## Accessibility Design Review Report

St. Michael's Uniting Church  
120 Collins Street  
Melbourne, Victoria

Dated: 09 December 2024

Reference: EG-241208-AC

**P1** Proposed Floor Plans  
Proposed Ground Floor Plan - R.G-02 East Lobby  
1: 25 @ A1

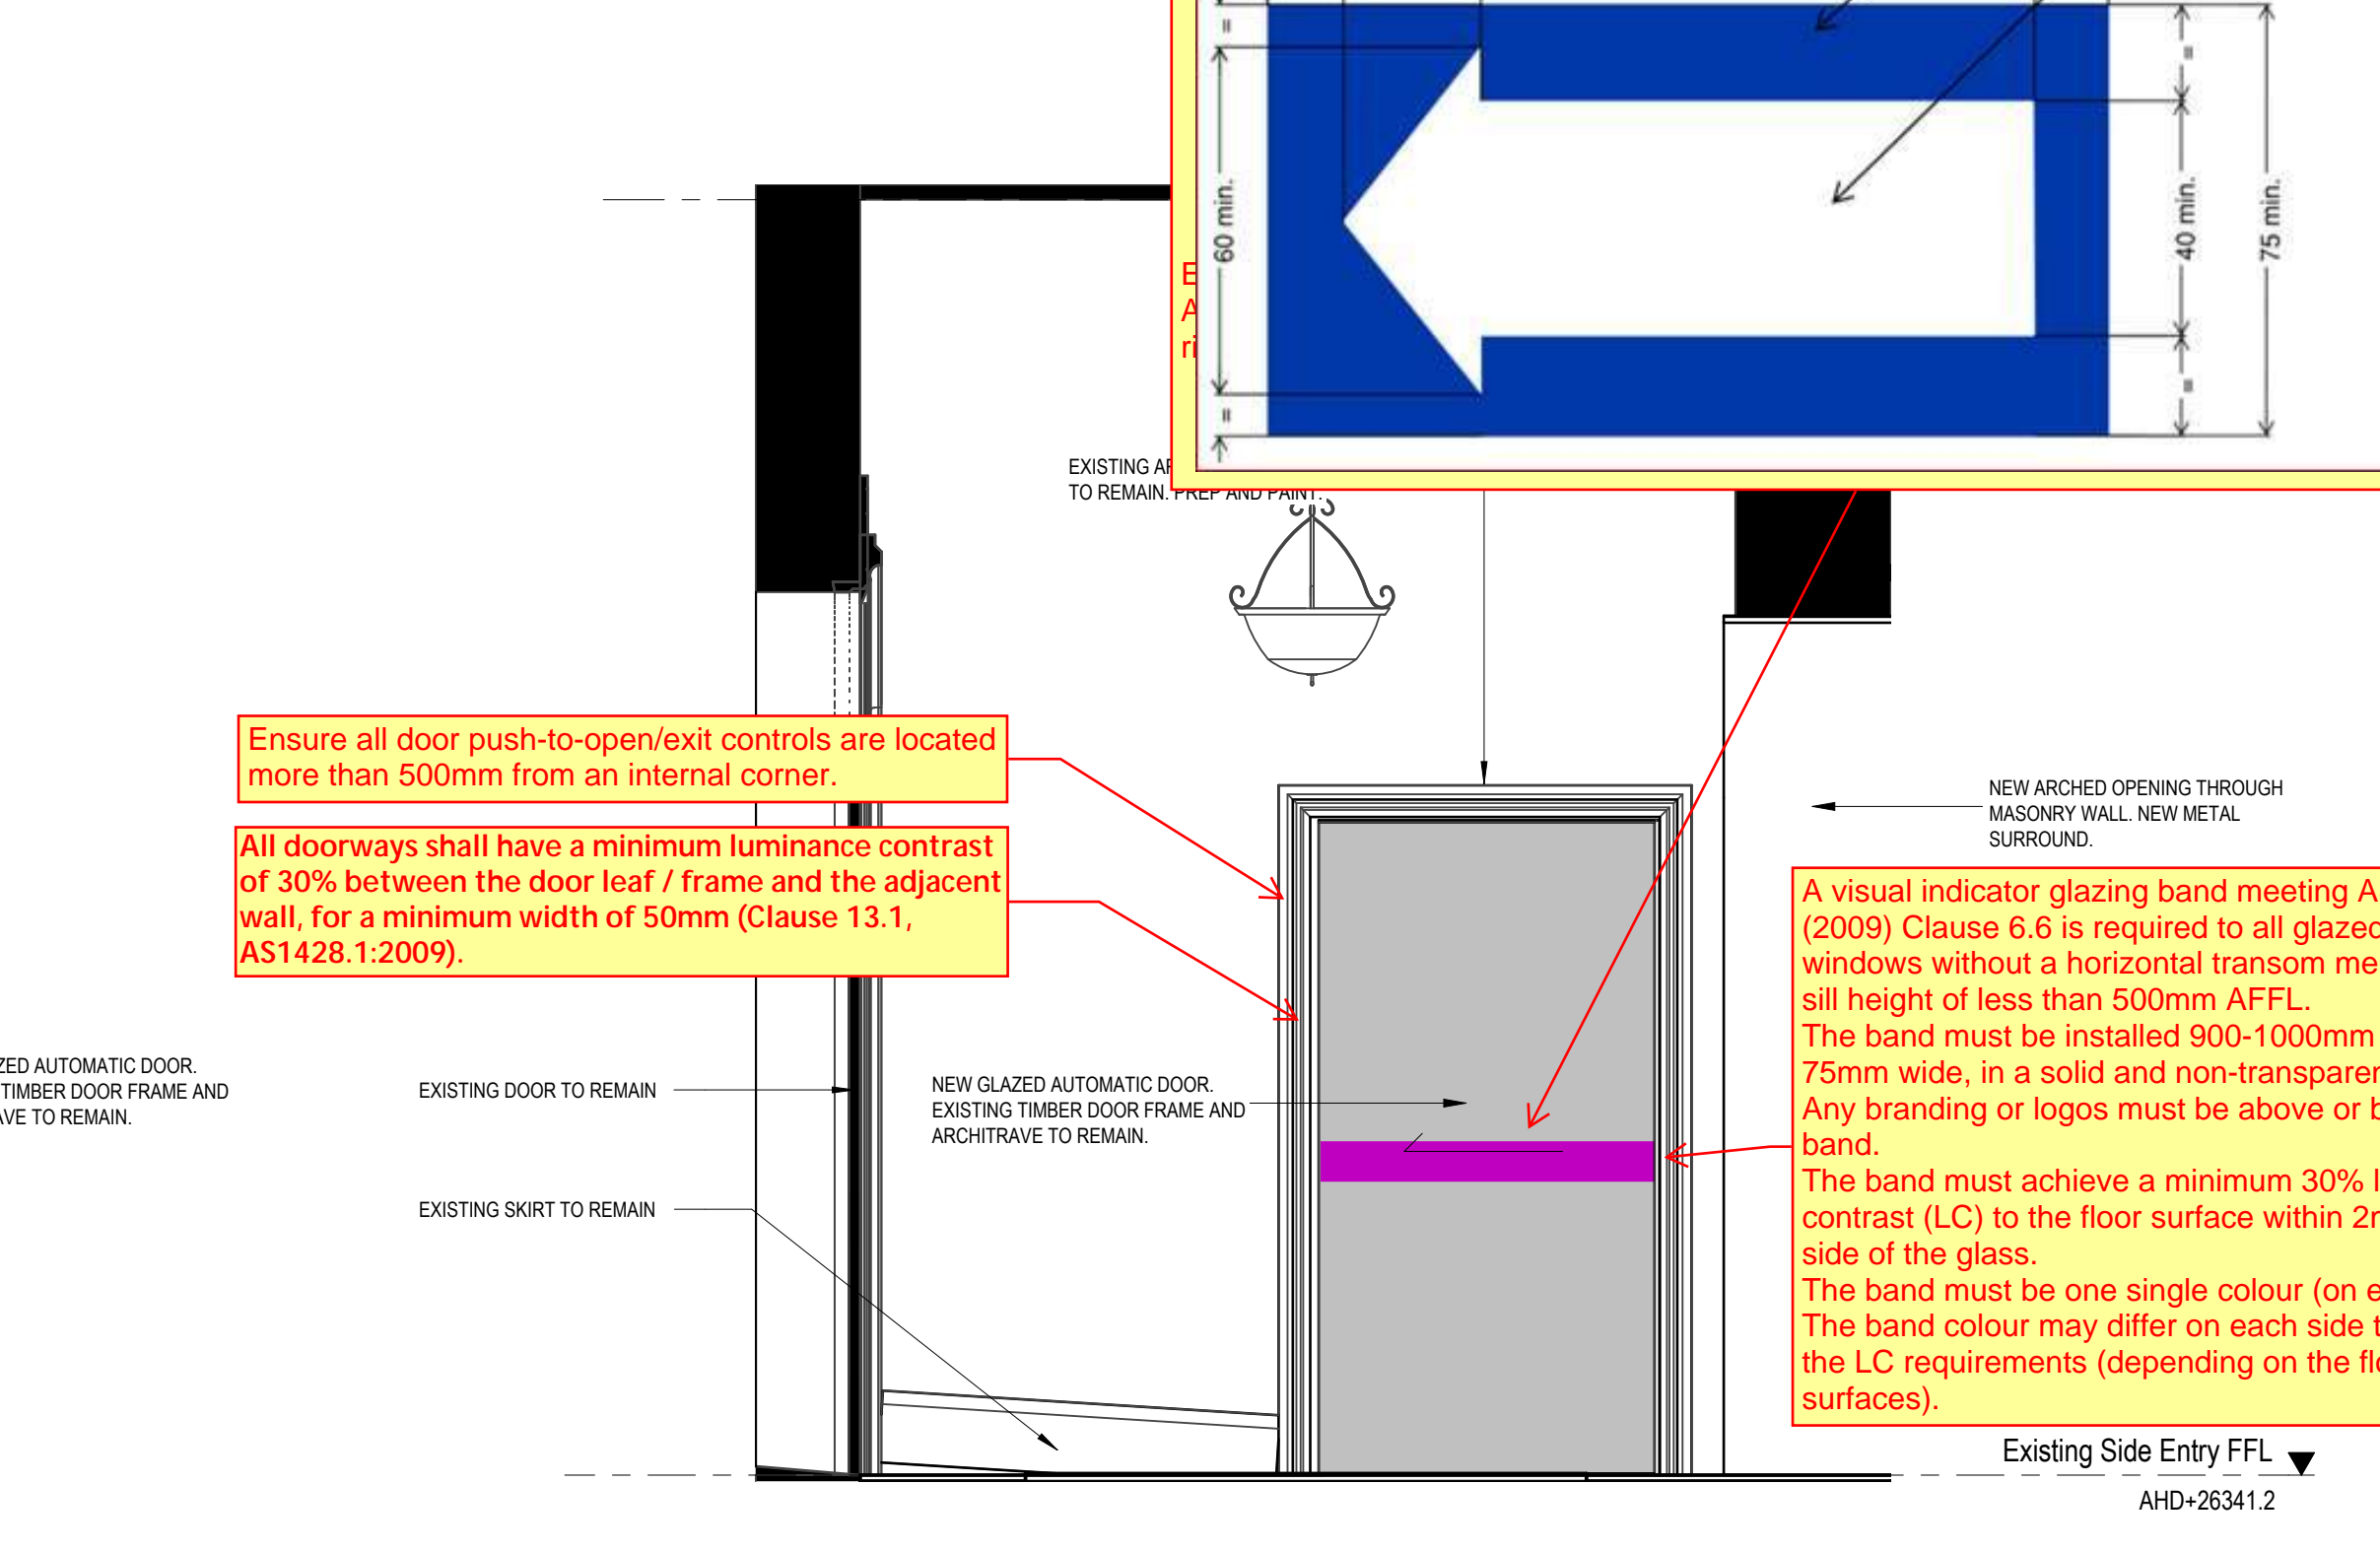
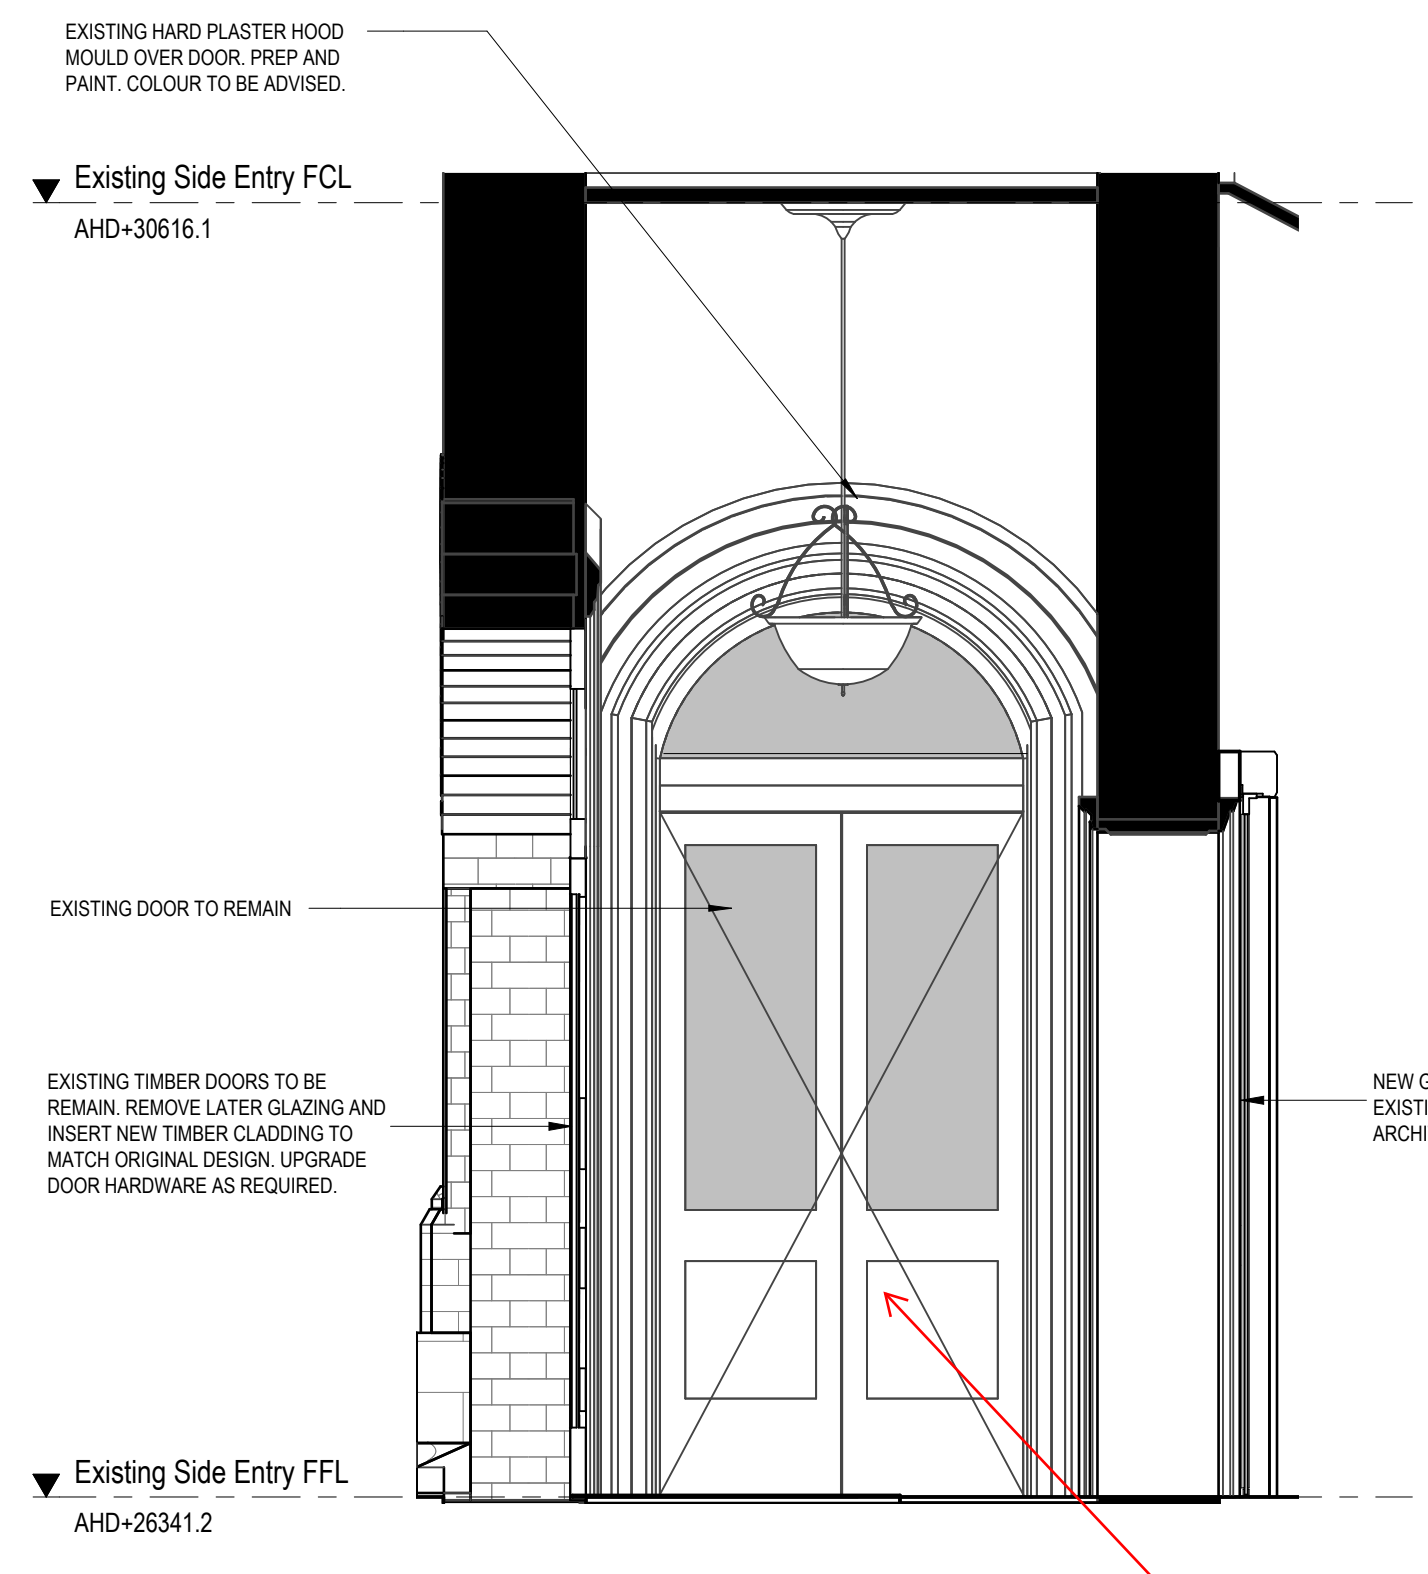
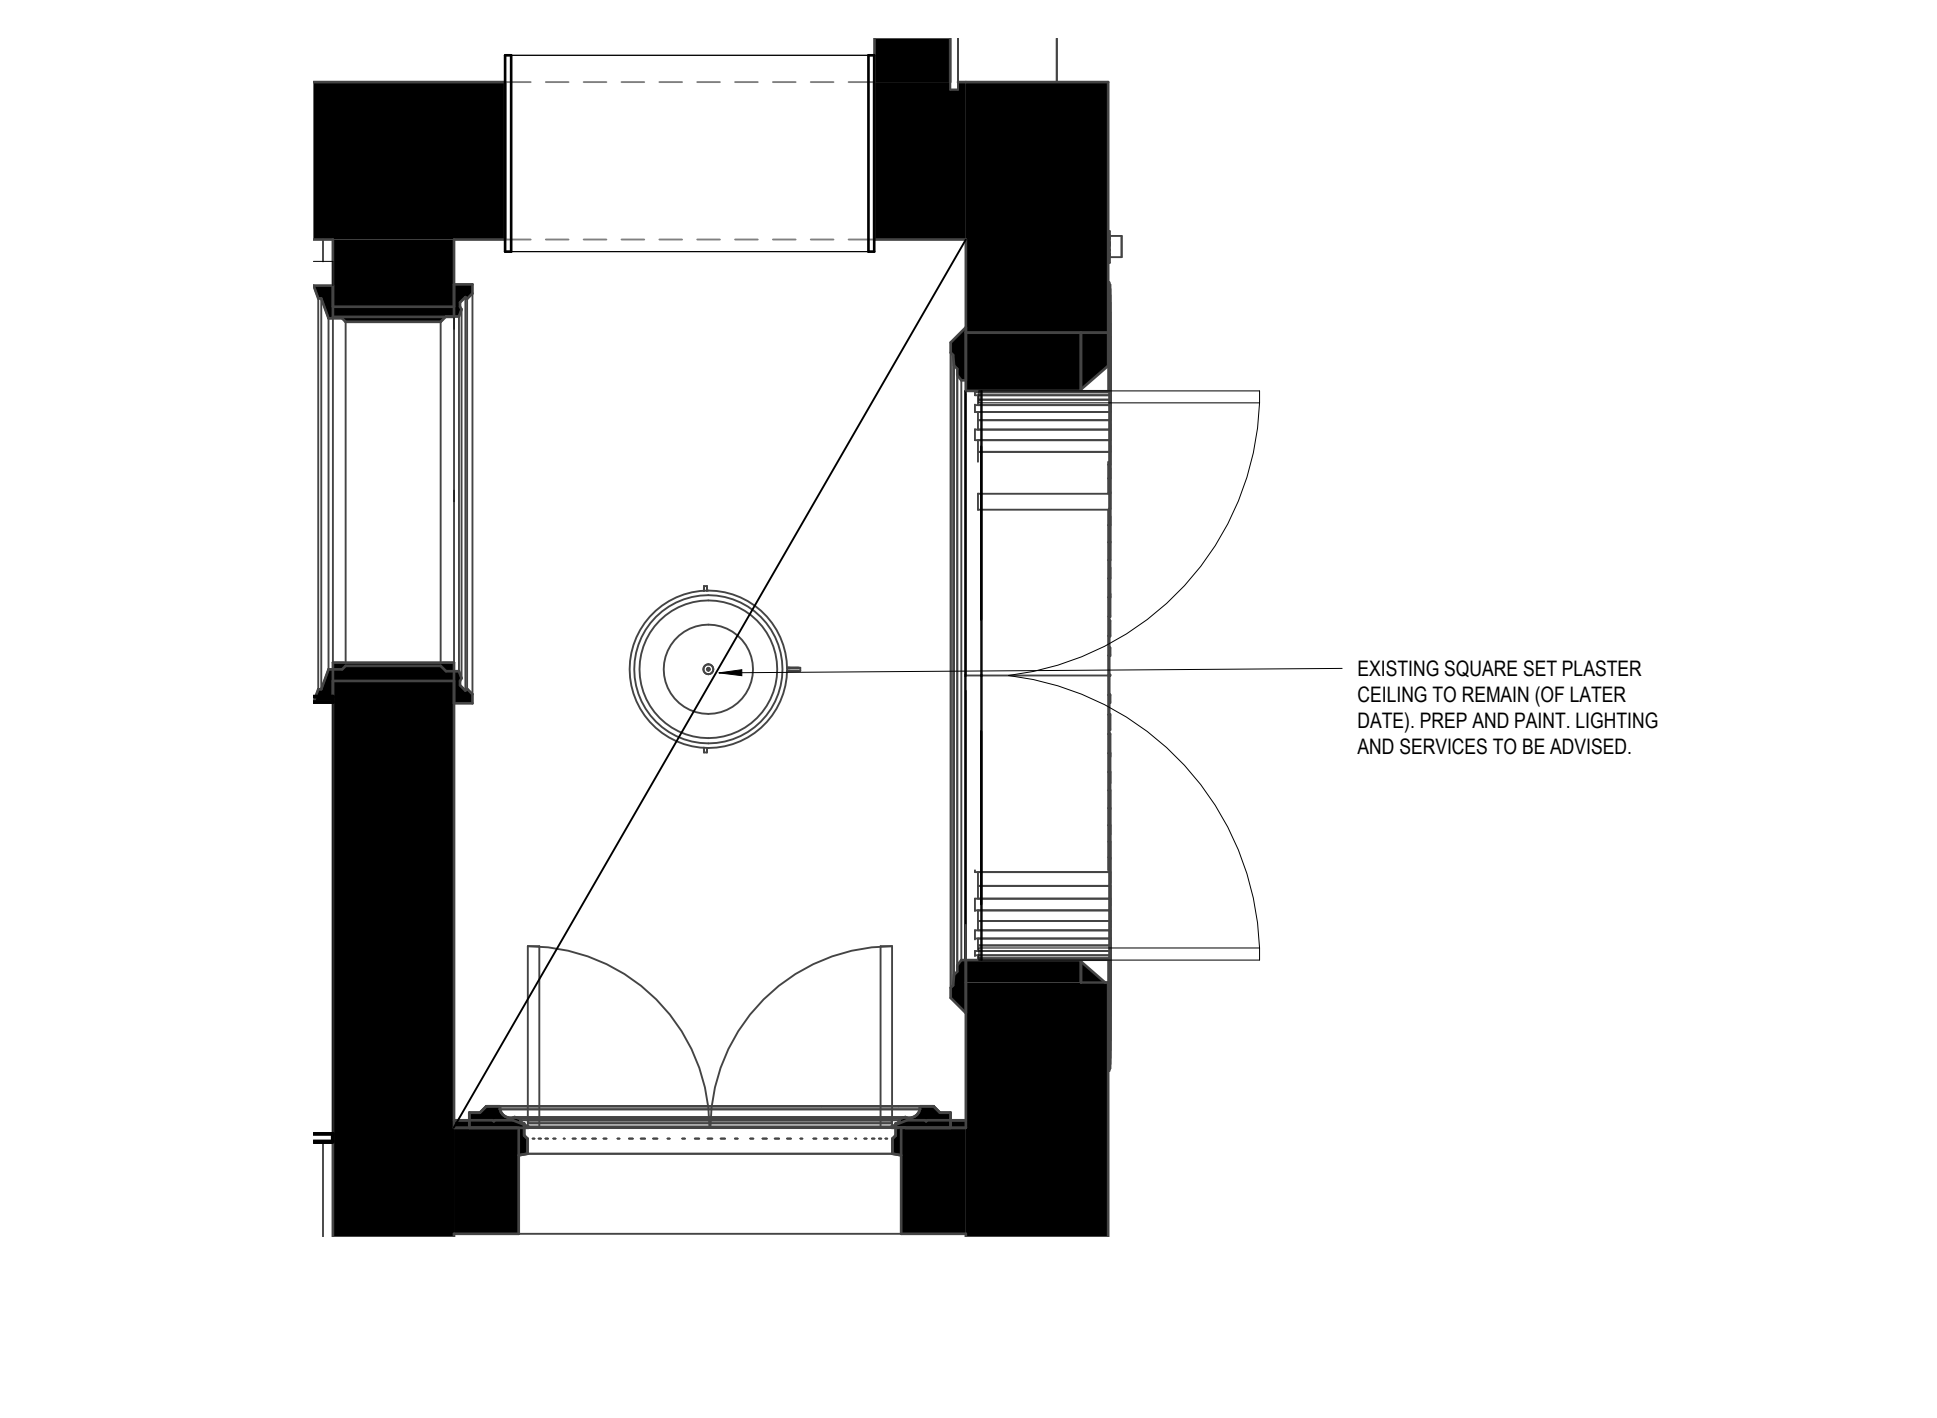
Signage must be visible on both sides of the automatic sliding door in accordance with AS 5007. The expected signs are shown below (in accordance with AS 5007).
